# Access Strategy Note

**Project name:** Land south of Eccles Substation, Coldstream  
**Author:** JK  
**Date:** 28<sup>th</sup> October 2025  
**Project number:** P24-0160

- 1.8. A meeting has been held on the 25 September 2025 with the Scottish Borders Planning and Roads officers to discuss and agree the further information required. It was agreed that a supplementary Access Strategy Note would be provided which addresses the above LRA comment by providing the information in the form of this Access Strategy Note which comprises the following:

**Plate 2.2 – Existing Site Access Levels**

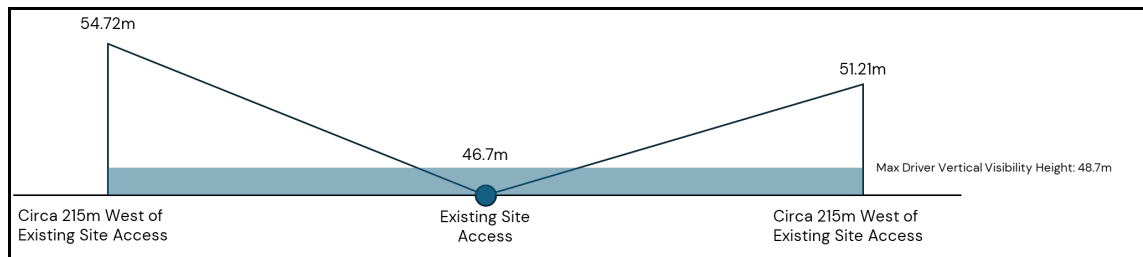
*As this proposed BESS site is immediately adjacent to another site which already benefits from an upgraded access, I will require an explanation as to why an agreement cannot be reached to use this existing access.*

- 3.15. The carriageway levels indicate respective increases of approximately 8.02m and 4.51m in comparison to the access level. The available horizontal visibility from the existing site access, considering the standard HGV driver eye height (vertical visibility), measures 65.95m to the west and 62.41m to the east.

- 3.16. At the required 215m visibility distance as prescribed by DMRB for a 60mph road, the measured level differences of roughly 8m and 4.5m exceed the permissible maximum driver eye height of 2.00m above carriageway level, equivalent to 48.7m AOD in this context, which may adversely affect visibility.

- 3.18. These elevation differences mean the existing access does not meet DMRB minimum sight distances and likely won't be considered safe for increased use by the LRA.

- 3.19. Given the above the existing field access at Bishops Dal is considered unsuitable for retention for formal use and temporary intensified traffic volumes due to non-compliance visibility requirements set out in DMRB CD 109.

**Plate 3.3 – Emergency access Options**

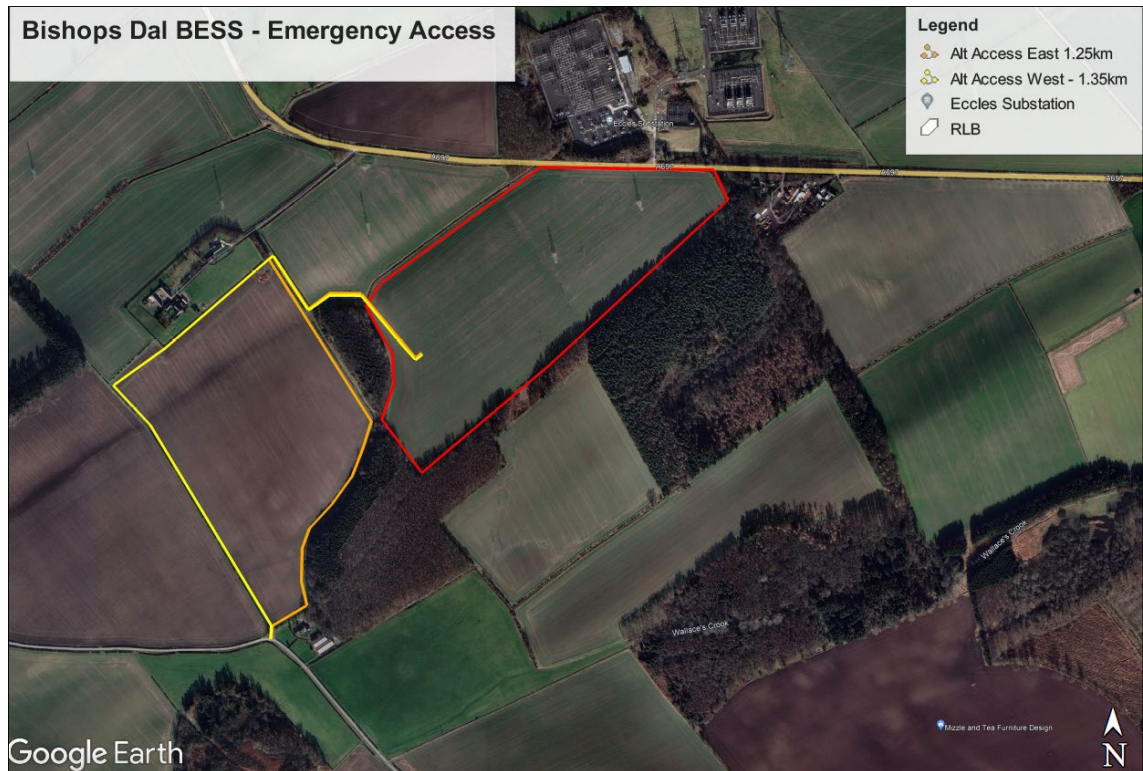
*Furthermore, we expressed concerns with the proposed emergency access south of Puncheon Bridge. Having visited the location there are existing trees and hedges/fences within the proposed visibility splay to the west, which appear to be outwith the verge and the applicant's control. Further information should be provided in this regard."*

- Follow the unnamed road north for a distance of circa 1.7km to a field access which leads north. Access into a field is required.
- 3.41. The emergency access route was considered to be too indirect, not obvious which could cause wayfinding issues in the event of an emergency.

- 3.42. Additionally, the applicant has no land ownership or control over the adjacent field to the south of the development site, nor any mechanism to compel or secure use of the field access from the un-named road to the south. As such, the southern emergency access arrangement is not deliverable in practical or legal terms.
